Supporting Content for Comment 111 SCMR_CH Limit Adjustment

Jason Ellison, Howard Heck, and Austin
Stegall | TE Connectivity

November 2025 Plenary

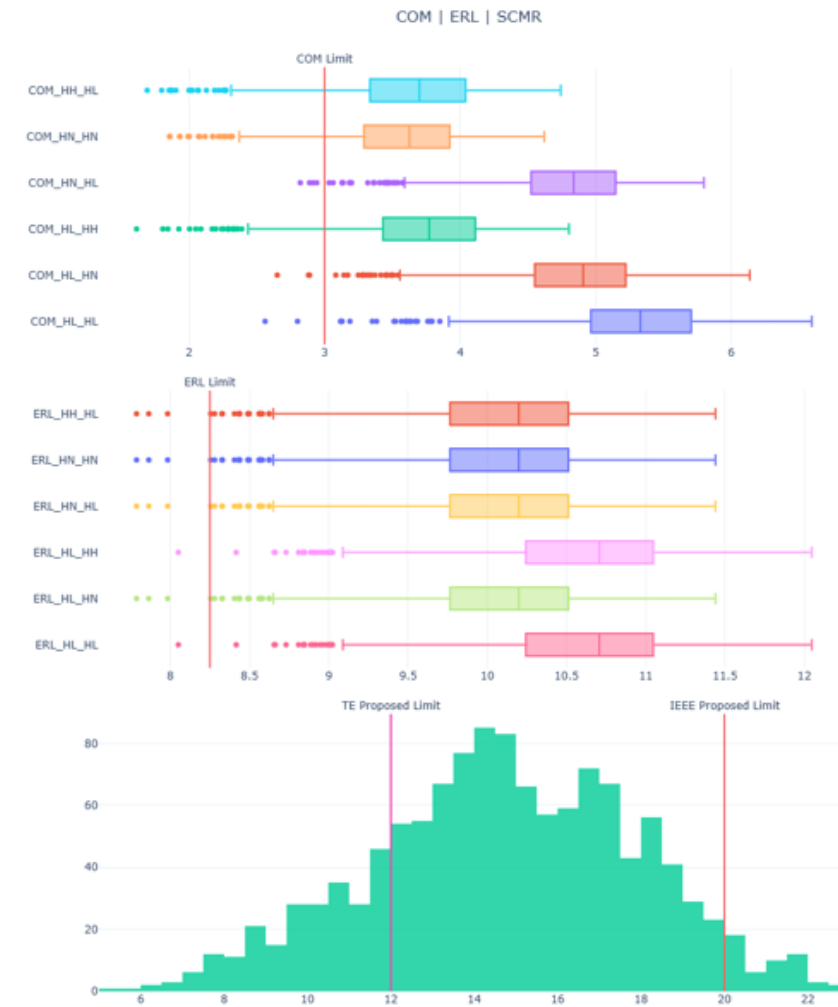
Draft 2.1 introduced Channel Signal to Common-mode ratio, SCMR_CH, as a normative metric in Table 179-14 with minimum limit of 20. Information demonstrating correlation between SCMR_CH and field failures has not been presented.

SCMR_CH was calculated from data of 77 1m OSFP cable assemblies (1232 differential pairs). 4.1% of the differential pairs and 0% of cable assemblies passed this criteria. This is out of alignment with the number of cables passing mode conversion insertion loss from Draft 2.0: 94.93% differential pairs and 66.23% cable assemblies.

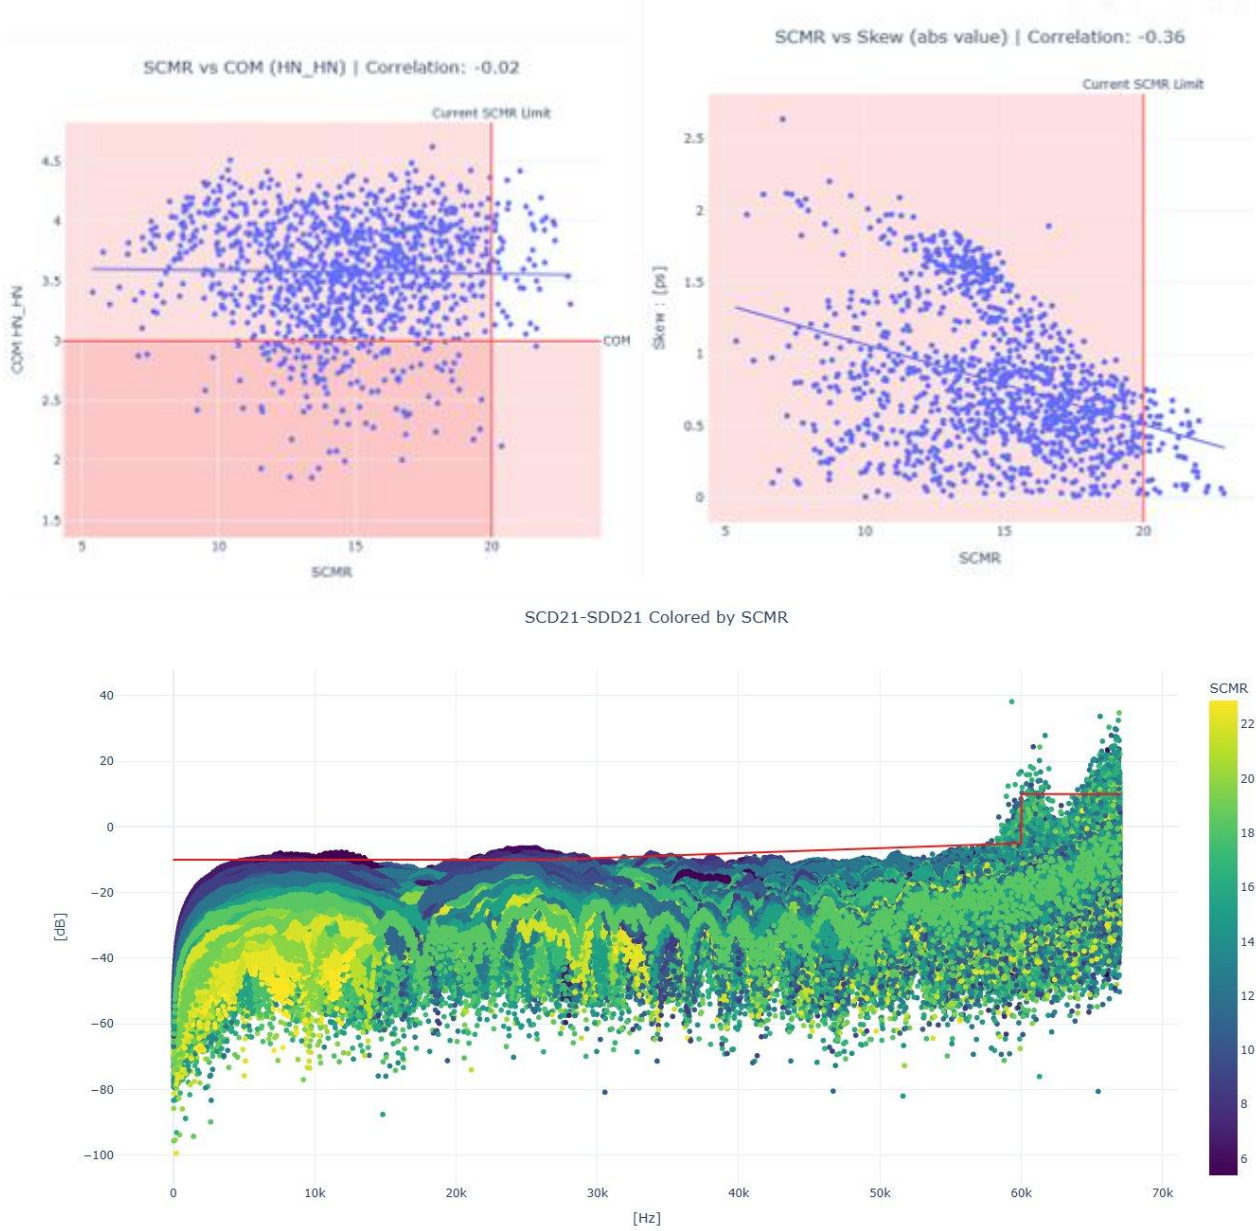
COM is very weakly correlated to SCMR_CH . Meaning, COM is not capturing the effects of skew and imbalance, and another metric such as SCMR_CH is needed.

SCMR_CH is moderately correlated to skew. Which indicates SCMR_CH is capturing the effects of asymmetry reasonably well.

SCMR_CH values trend with mode conversion insertion loss. This indicates SCMR_CH is capturing the effects of mode conversion insertion loss and could be used as a replacement. Further, SCMR_CH values lower than 12.01 are failing the mode conversion insertion loss frequency domain mask limit in D2.0.

Without data to correlate field failures with SCMR_CH, an analysis has been performed to correlate SCMR_CH with The mode conversion insertion loss specification in Draft 2.0. Using this data, it is recommended changing the SCMR_CH minimum limit in table 179-14 to 12.0.

This value has been shown to be consistent with the previous mode conversion insertion loss limit in Draft 2.0 and is consistent with currently available hardware and process capability.
